UNITED STATES
ATOMIC ENERGY COMMISSION

SMITH HINCHMAN & GRYLLS, INC.
ARCHITECTS & ENGINEERS
DETROIT 26 MICHIGAN
D 4W180 T L E

AIR CONDITIONING
BASEMENT PLAN & SECTION

Basement Plan
Scale 1/4" = 1'-0"

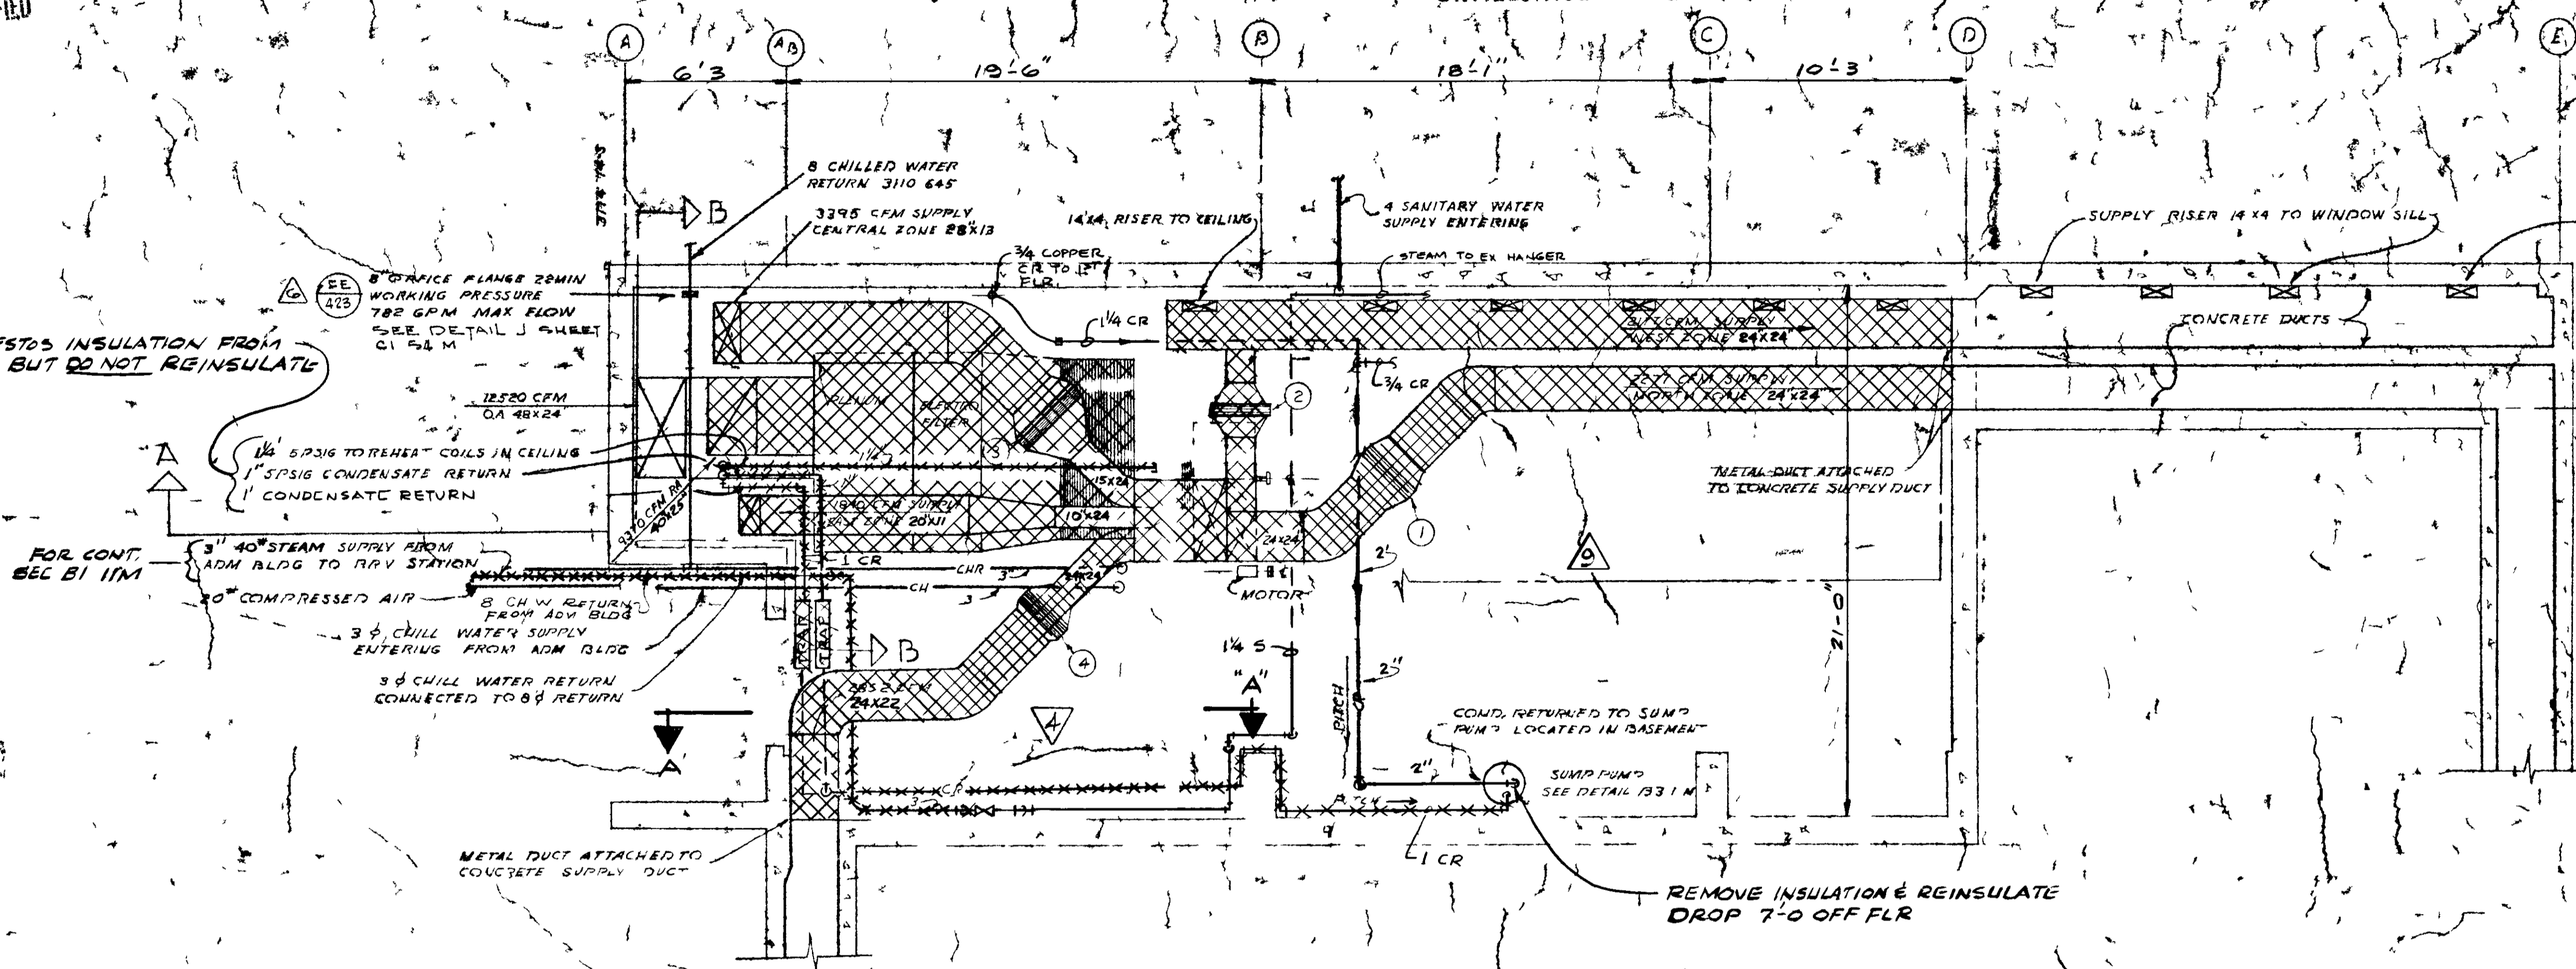
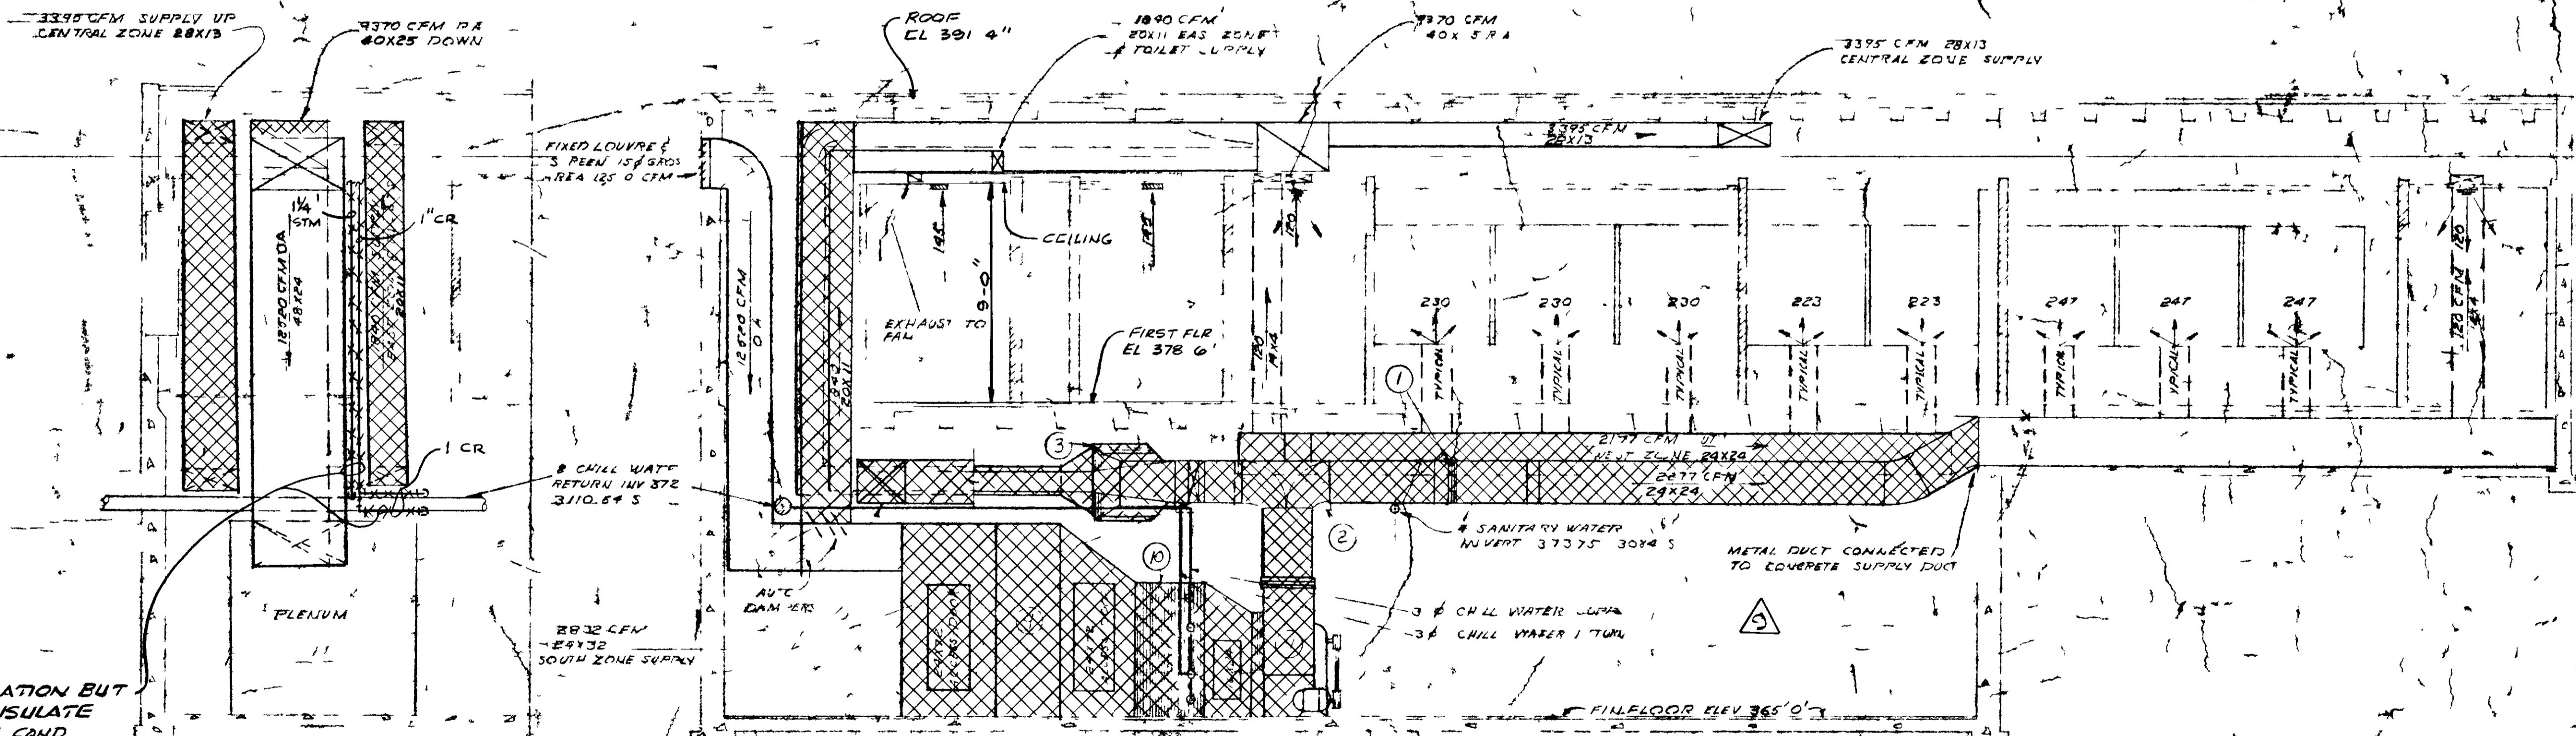
REMOVE ASBESTOS INSULATION FROM THESE LINES BUT DO NOT REINSULATE

1. ONLY AREAS ENCIRCLED AS REV 9 INCLUDED IN FPSC #A2020
2. REMOVE ASBESTOS INSULATION ON HVAC EQUIPMENT, DUCTWORK AND PIPING AS SHOWN ENCIRCLED AND CROSSHATCHED. REINSULATE, EXCEPT WHERE NOTED, PER SUBCONTRACT SPLL'S
